APPLICATION FOR MATERIAL LICENSE

B AMENDMENT TO LICENSE NUMBER 24-15595-1

Response: Additional Information to Control Number 316804

Aptuit, Inc.
NRC License Number 24-15595-01
Amendment Request
March 31, 2008
Control Number 316804

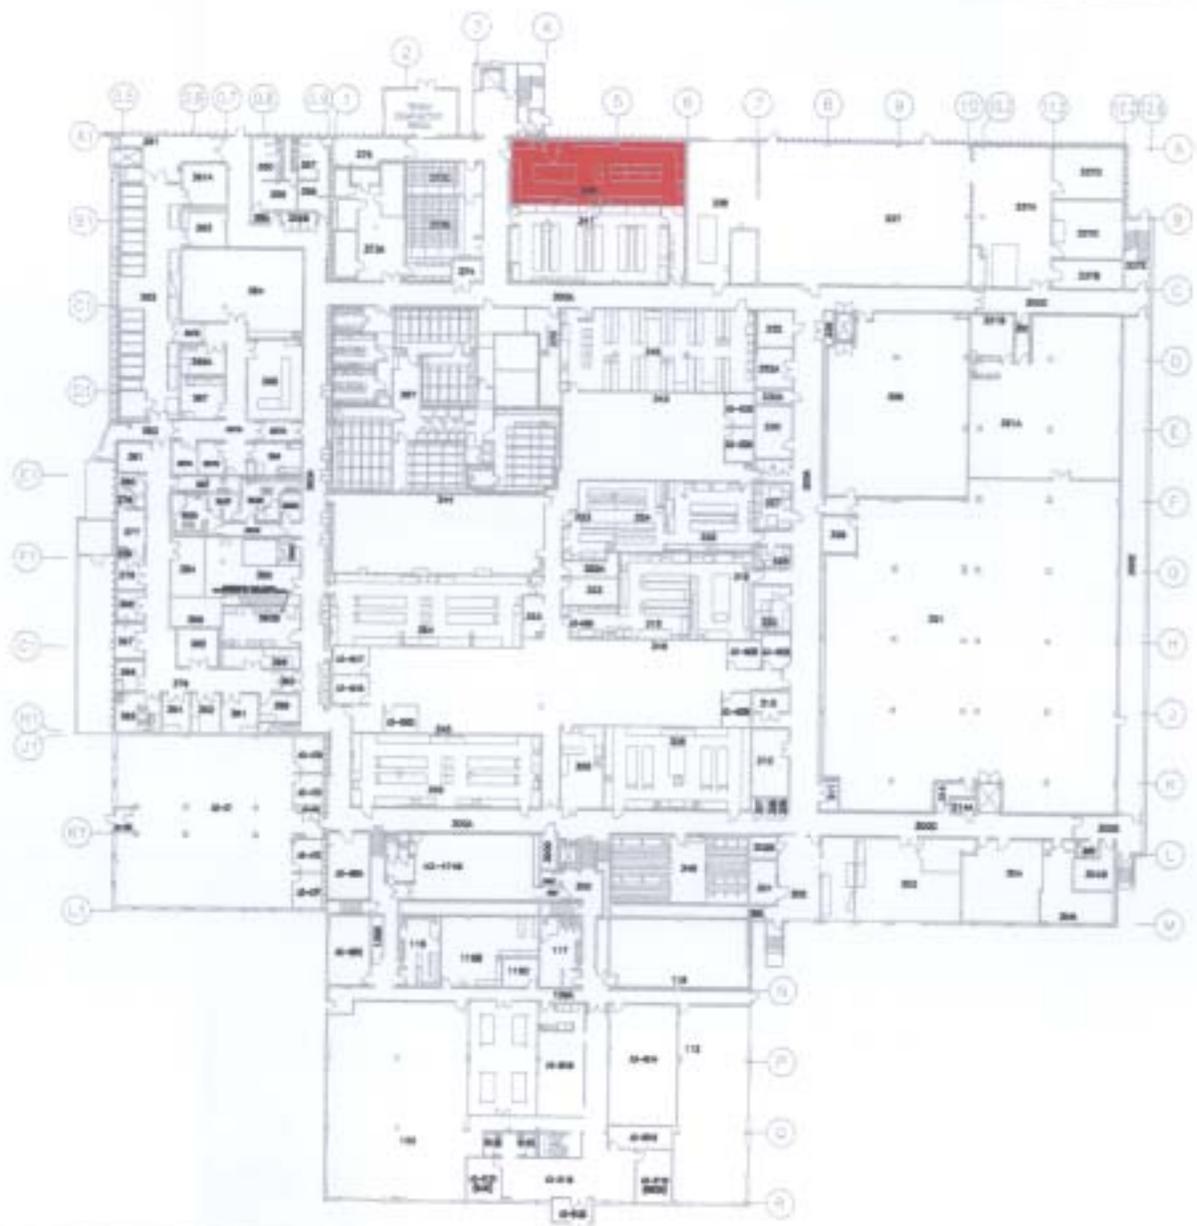
Describe the types of radiosynthesis studies that will be conducted. Include nuclides involved, frequency of studies performed, and typical quantities of each radionuclide that will be used at any one time.

Custom chemical radiosynthesis will be performed per contract with our clients in the Active Pharmaceutical Ingredients (API) area of B2 (refer to the Synthesis Area Floor Plan in Attachment 5). Custom chemical radiosyntheses are usually contracted only once and work is not repeated, therefore there is no single defined product that is made on a regular basis. The B-2 area was designed incorporating several of Aptuit's principles of "designing a better drug process."

The radiochemistry area of B-2 consists of a change room, a Nuclear Magnetic Resonance (NMR) laboratory, a non-GMP radiosynthesis laboratory, a radioanalytical laboratory, and several Current Good Manufacturing Practice (CGMP) suites. The radiochemistry area will utilize radioisotopes including C-14, H-3 and S-35. B2 is located on the ground floor of the B-building. The radiochemistry area has a dedicated air handling system (refer to AC-B01 HVAC Schematic in Attachment 5).

① AC-R01 HVAC SCHEMATIC

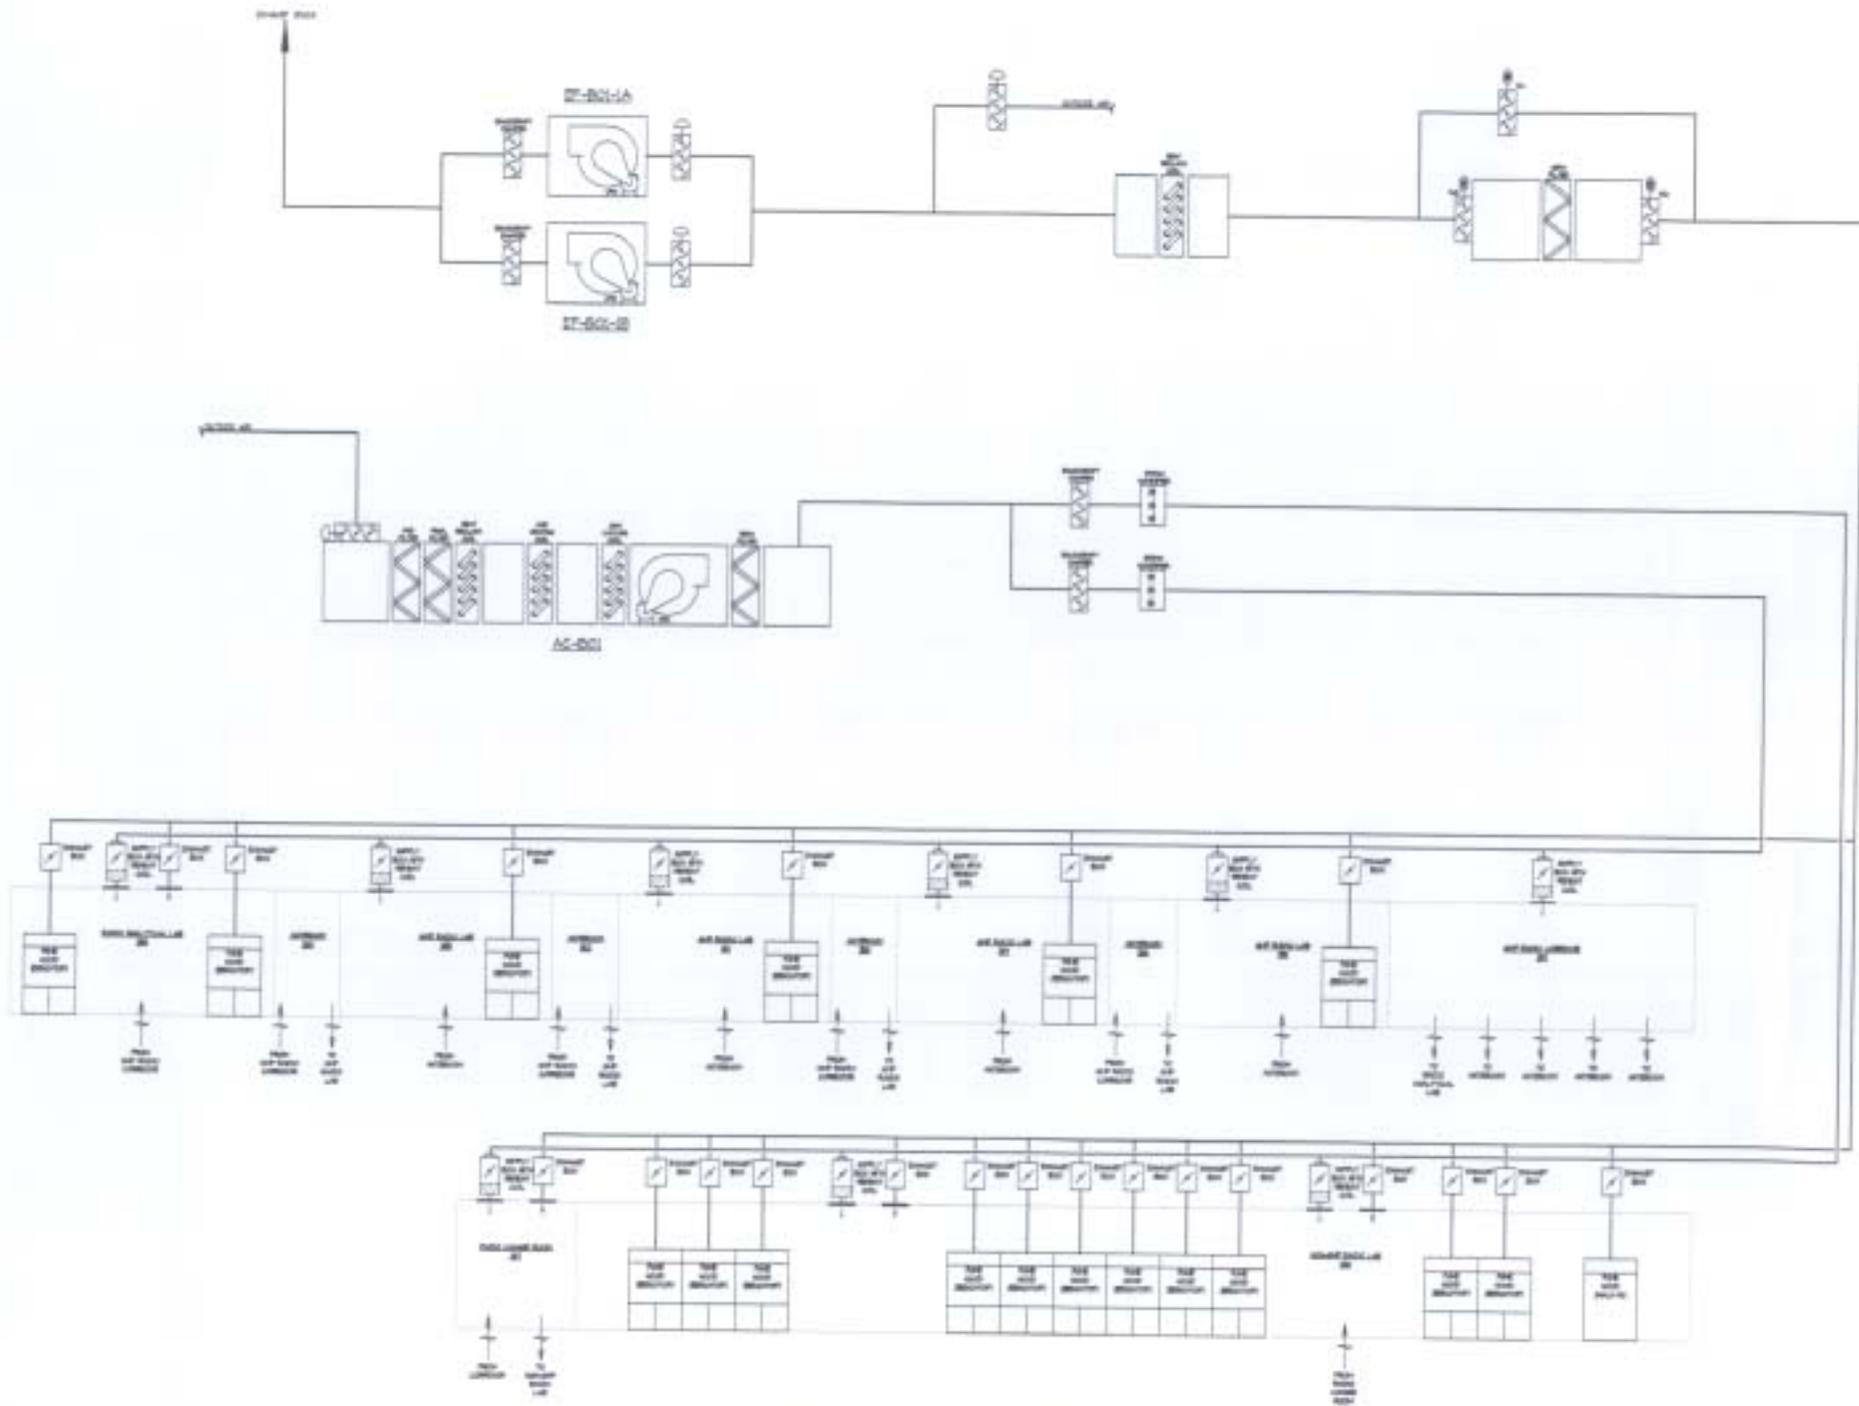
Describe equipment used to filter radioactively contaminated air/water before effluents are released to the environment. Include a description of the methods that will be used to evaluate these filtration systems for saturation.

A dedicated air-handling unit serves the CGMP Radio Labs, Radioanalytical Lab and Non-GMP Radio Lab portions of the facility (refer to AC-B01 HVAC Schematic in Attachment 5). The supply fan motor for the unit is equipped with a variable frequency drive and HEPA filters are installed on the downstream side of the supply fan. The supply fan motor is on emergency power. Individual rooms connected to the air-handling unit have lab supply air terminals with heating hot water reheat coils to maintain the space temperature set points and space pressurization.

Two exhaust fans are installed on grade to the west of Building "B" and serve the CGMP Radio Labs, Radioanalytical Lab and Non-GMP Radio Lab portions of the facility. The exhaust fans are redundant fans and are connected to a common exhaust stack. The exhaust stack is 30 inches in diameter and 60 feet tall. The exhaust stack extends 20 feet above the roof and the exhaust velocity of the exhaust stack is greater than 3000 feet per minute. There are two grade level outside air intake louvers below the stack. The nearest louver is approximately 50 feet away from the stack discharge and the other louver is approximately 75 feet away. There are multiple roof mounted air handling units on the roofs of the buildings within the site. The nearest outside air intake for one of these roof mounted air handling units is 80 feet away from the stack discharge. All other outside air intakes for the multiple roof mounted air handling units are over 145 feet away from the stack discharge.

The exhaust fan motors have variable frequency drives and are connected to emergency power. Exhaust ductwork is routed from the exhaust fans through a heat recovery coil and then into the west side of Building "B". The exhaust ductwork is then routed through a HEPA filter housing and then to lab exhaust air terminals that

are connected to fume hoods and exhaust grilles within the labs to maintain space pressurization. New low airflow fume hoods with two position control are installed within the new labs. Each fume hood is connected to a lab exhaust air terminal that controls the exhaust airflow for each fume hood.

The HEPA filters for the systems are 99.99% efficient on 0.3 micron size particles and are tested bi-annually for HEPA certification. In addition, the differential pressure across the HEPA filters is continuously monitored by the Siemens Building Management System and an alarm is generated when the differential pressure is at level as indicated by the HEPA filter manufacturer for the filters to be replaced. The filter housing for the exhaust HEPA filters is a bag-in/bag-out system.
